SUNDRY NOTICES AND REPORTS ON WELLS

ConocoPhillips Company

SJ 31-6 Unit #206A

BOP Configuration

For Cavitation Program

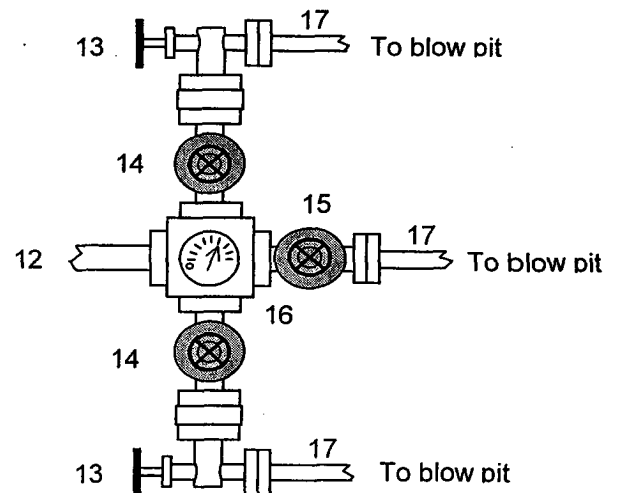
Due to problems with the planned BOP Key Energy was using, ConocoPhillips needs to change the BOP configuration initially submitted to the following:

- Change in BOP to a double ram instead of an annular and single ram
- To request an exception to Onshore Order #2 to
 - Allow us to test our BOP and 9-5/8" surface casing to 1000 psi in lieu of Onshore Order #2 requirements
 - Allow us to test our BOP and 7" casing (for the cavitation program) to 1800 psi in lieu of Onshore Order #2 requirement.

This BOP arrangement and test program is for the cavitation program. The BOP will be installed on the tubing head. The 7" casing will be pressure tested against closed blind rams to 200 psi to 300 psi for 2-3 minutes and to 1800 psi for 30 minutes - this test pressure is 48% of the minimum internal yield strength of 3740 psi for the 7", 20#, J-55, STC casing. The pipe rams and choke manifold will be tested to 200 psi to 300 psi (low pressure test) for 2-3 minutes and to 1800 psi (high pressure test) for 10 minutes - This test will be done with a test plug or possibly without a test plug (ie against casing). If we conduct this test without a test plug we will ensure that we have sufficient drillstring weight in the hole to exceed the upward force generated by the test.

We use a power swivel and air/mist to drill the 6-1/4" hole in our cavitation program. We do not use a kelly. In addition to the equipment in the above diagram the following equipment will comprise the BOP system:

1. String floats will be used inside the drillpipe
2. Stab-in TIW valve for all drillstrings in use
3. Each blooie line is equipped with a hydraulically controlled valve (HCR valve).
